Lower Thames Crossing

9.89 Responses to the Examining Authority's ExQ1 Appendix G – 11. Biodiversity (Part 2 of 6)

Planning Inspectorate Scheme Ref: TR010032
Examination Document Ref: TR010032/EXAM/9.89

Figure 1: *Epping Forest SAC and Air Quality Receptor Grid*

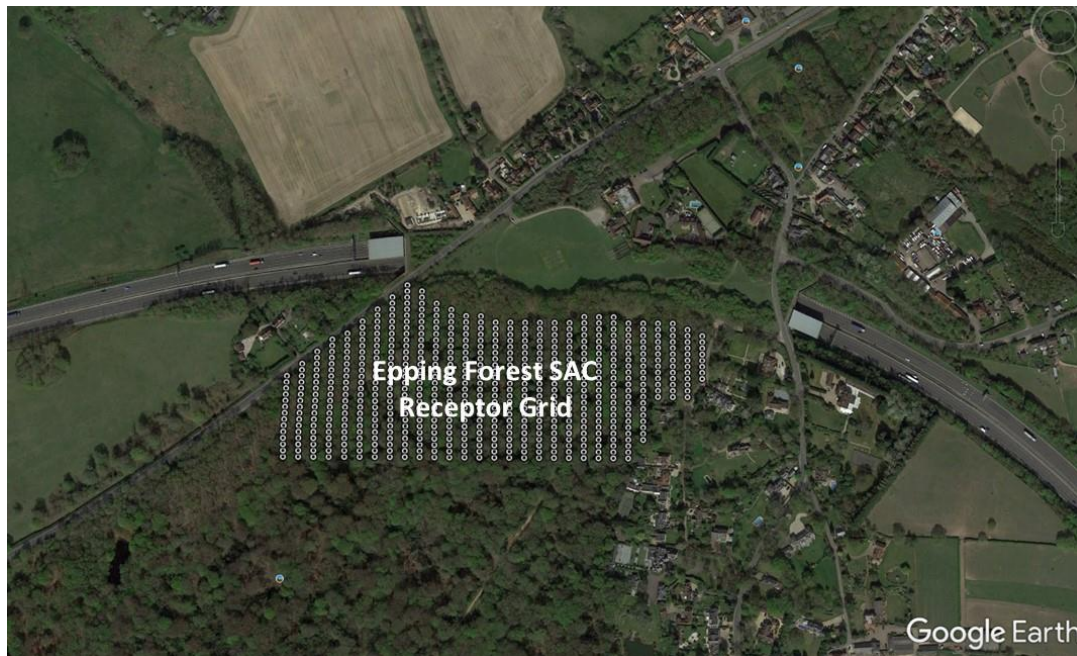
- The referenced 'origin of the point in the SAC where nitrogen was modelled to exceed 0.4kgN/ha/Year' is not made clear within Figure 1 in Appendix A. This needs to be shown and described more clearly on the Figure 1 and in the text and any 'origin' relevant to our requested 0.1kgN/ha/year total N loading should also be shown to enable relevant HRA assessment consistent with my advice to date.

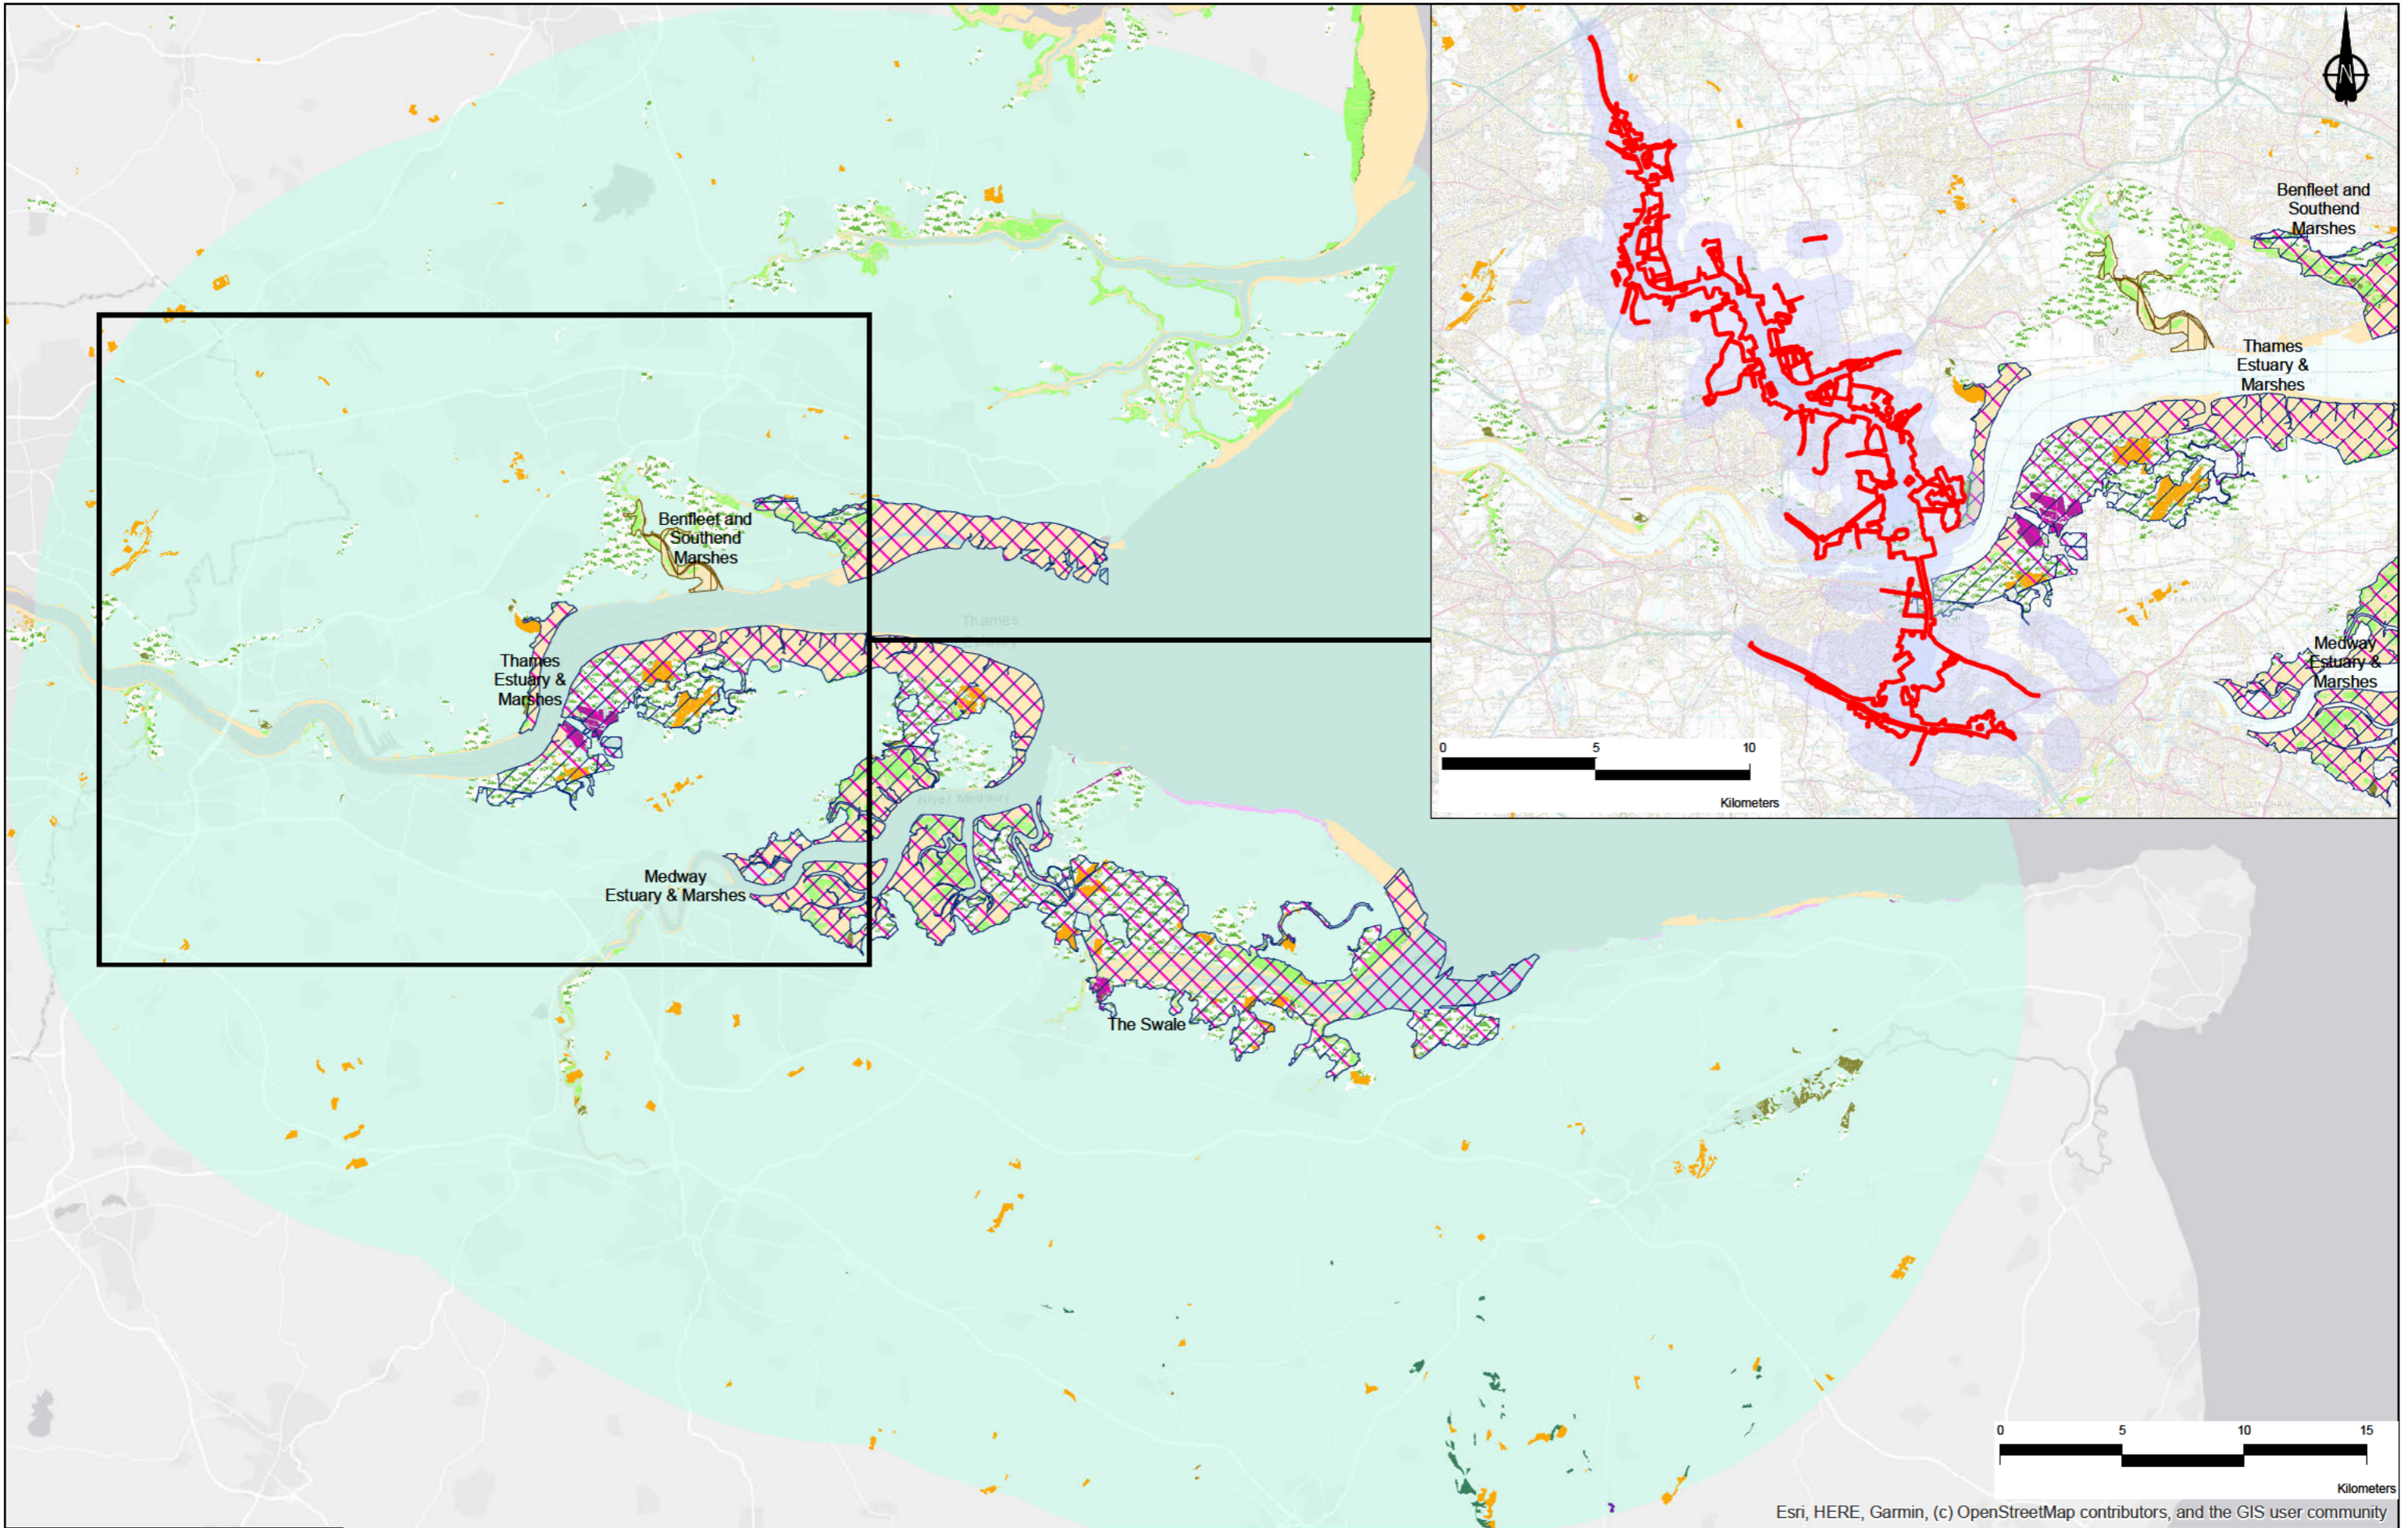
Figure 18 shows the bird distribution overlaying the noise (unmitigated) and visual zones of influence that are used in the assessment, which includes the construction of the tidal gate (the label on the drawing highlights the location)
